# Access Compliance Report

## Public Rights-of-Way

Intersection ID: 45173	Main Street: LINDEN_TREE_LN	Cross Street: MAPLEHURST_DR	Location: NE
ADA ID: E78BD0971A93	Ramp Type: PerpDiag	Initial Pass/Fail: Fail	Overall Compliance: No
Severity Score: 21.25			
Codes/Mitigation Info/Possible Solution		Field Measurements/Component Compliance

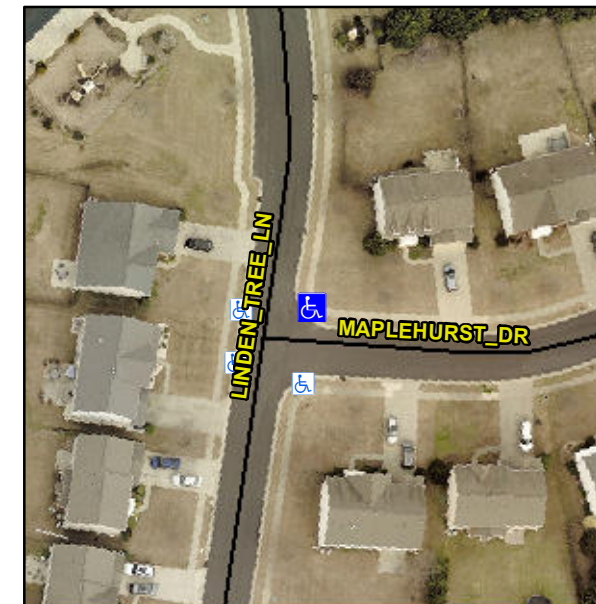
**Not Found, R304.5.1, R304.2.2**

Compliance	Description	Data	Compliance	Description	Data
N/A	Ramp Length (in)	48.0	No	Ramp Slope (%)	8.5
No	Ramp Width (in)	47.0	Yes	Ramp XSlope (%)	1.4
N/A	Flare Type LT	N/A	N/A	Flare Type RT	N/A
N/A	Flare Slope LT (%)	N/A	N/A	Flare Slope RT (%)	N/A
N/A	Flare Traversable LT?	N/A	N/A	Flare Traversable RT?	N/A
N/A	Landing Length (in)	N/A	N/A	DWS Provided?	N/A
N/A	Landing Width (in)	N/A	N/A	DWS Contrast?	N/A
N/A	Landing Slope (%)	N/A	N/A	DWS Length (in)	N/A
N/A	Landing X Slope (%)	N/A	N/A	DWS Full Width?	N/A
N/A	Landing Curb? (Y/N)	N/A	N/A	DWS Offset (in)	N/A
N/A	Shared Landing?	N/A			
N/A	Gutter Ponding?	N/A	N/A	Gutter Slope (%)	N/A
N/A	Gutter Lip Ht (in)	N/A	N/A	Gutter X Slope (%)	N/A
N/A	Painted X Walk1?	No	N/A	Painted X Walk2?	No
	X Walk 1 Direction	To NW		X Walk 2 Direction	To SW
N/A	X Walk 1 Width (in)	N/A	N/A	X Walk 2 Width (in)	N/A
	X Walk 1 Slope (%)	1.8		X Walk 2 Slope (%)	0.1
	X Walk 1 X Slope (%)	2.3		X Walk 2 X Slope (%)	1.9

**Remove & Replace Curb Ramp With Two New Directional Ramps or Equivalent.**
